## *Fremont Siphon Replacement Project*

### **Community Design Workshop Summary**

January 12, 2013 10:00 a.m. to 2:00 p.m.

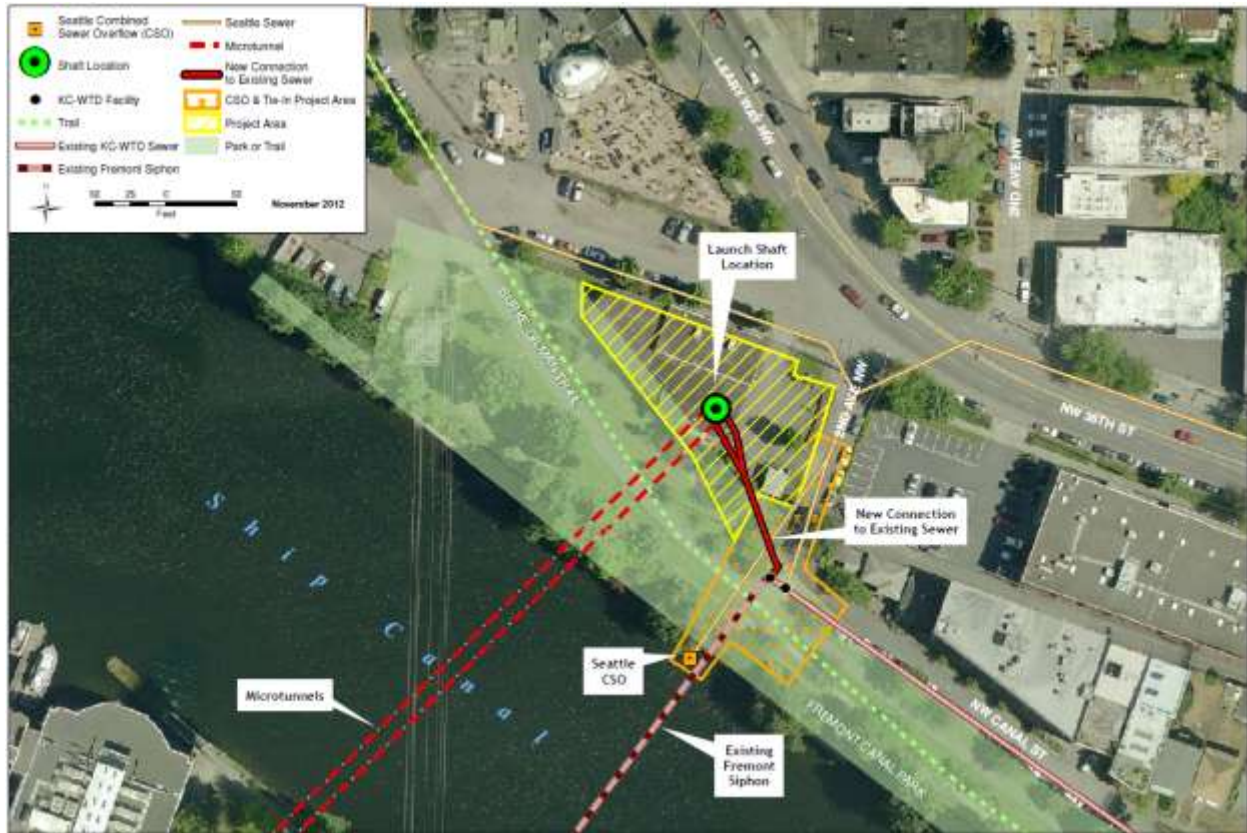
*Will construction activity occur on a larger area than the site shown?*

*Will the Burke-Gilman Trail be closed during construction?*

Yes. Additional space will be used for construction and construction staging than shown on the site plan.

The construction area is shown on the map below in yellow and orange. The area in orange is needed for only approximately three months to relocate the City of Seattle's combined sewer overflow (CSO) outfall.

No, the Burke-Gilman Trail will remain open during construction. During the relocation of the City's combined sewer overflow outfall (orange area in above map), King County plans to create temporary paved paths near the existing trail and not route the detours onto busy streets.
